# UNITED STATES PATENT AND TRADEMARK OFFICE

APPLICATION NO.	FILING DATE	FIRST NAMED INVENTOR	ATTORNEY DOCKET NO.	CONFIRMATION NO.
10/645,055	08/21/2003	Douglas A. Devens JR.	1001.2346101	6549

<b>Office Action Summary</b>	<b>Application No.</b> 10/645,055	<b>Applicant(s)</b> DEVENS ET AL.	
	<b>Examiner</b> VICTORIA P. CAMPBELL	<b>Art Unit</b> 3763

### **DETAILED ACTION**

*Fig. 2b*

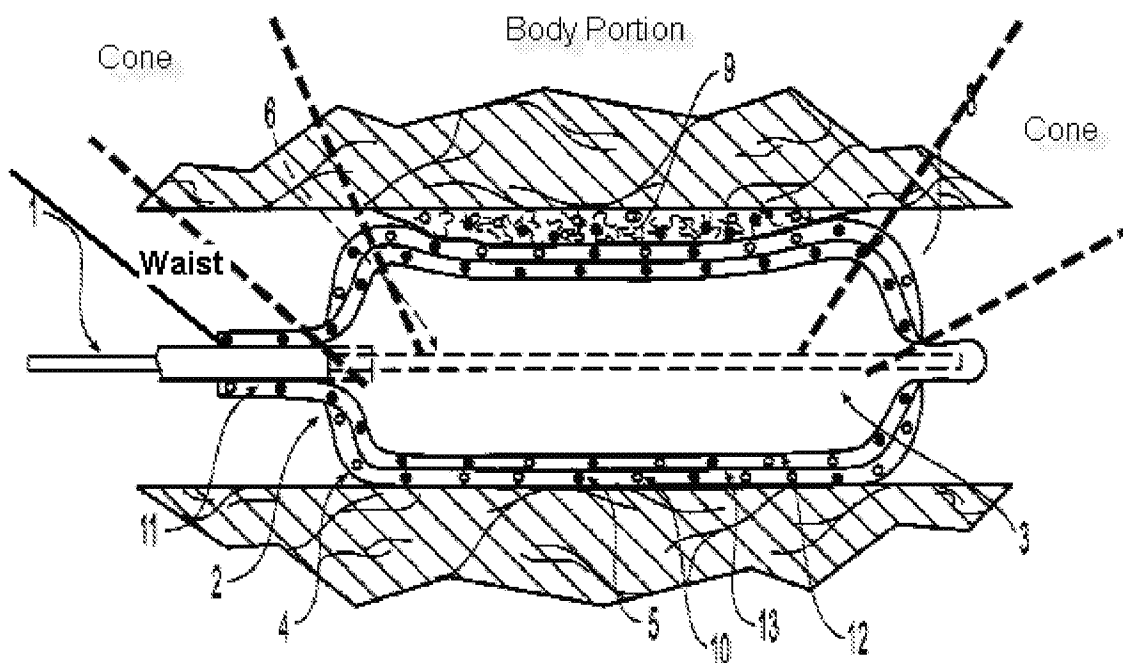
Regarding claims 1-3, 8, 10, and 12 Ding et al disclose a medical device comprising a balloon (3) comprising a first portion having a first length (2), and a second portion disposed on the first portion having a second length (4), wherein the second portion defines an outer surface of the balloon; wherein the first portion varies in thickness along the first length and the second portion varies in thickness along the second length (Figs. 2a, 2b; see right hand side), wherein the balloon has a waist portion, body portion, and a cone portion and wherein the first portion has a greater thickness at the body portion than at the cone portion (Fig. 2b; the body portion of the first portion is thicker than the tapered portion of the right-hand cone portion; see Fig. 2b reproduced below for clarification).

is disposed substantially entirely on the first portion, that the thickness of the first and second portions is generally constant in the cone portion (the tapering of the portions takes place only at the most extreme end of the cone portions, and therefore the thickness is maintained along substantially the entire length), and that the first portion extends substantially the entire length of the balloon (Figs. 2a and 2b). Ding et al fail to explicitly teach or disclose that the thickness of the waist portion of the first portion is less than the thickness of the body portion of the first portion. However, the examiner notes that at the time of invention, it would have been obvious to one having ordinary skill in the art to reduce the thickness of the first portion along the waist portion in order to reduce the profile of the balloon.
